Comments regarding Staff Report on Rummel/Heck Design Guidelines

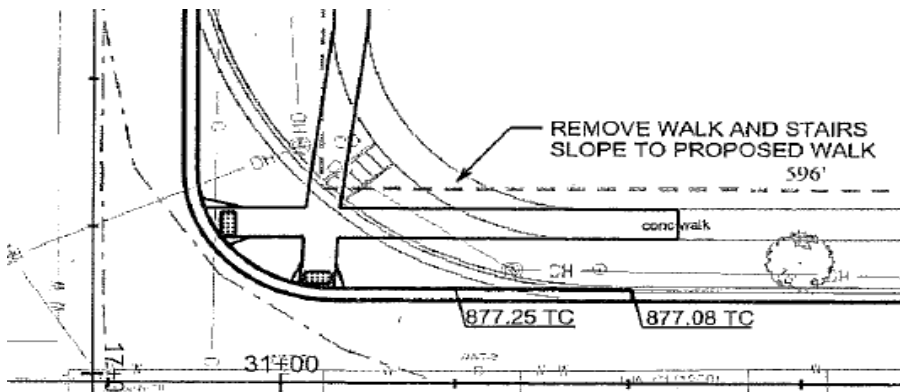
- (1) At least one carriage stepping stone was at risk when a part of Spaight Street was reconstructed. The City had marked the stone for removal, neighbors stepped in and the stone was saved.
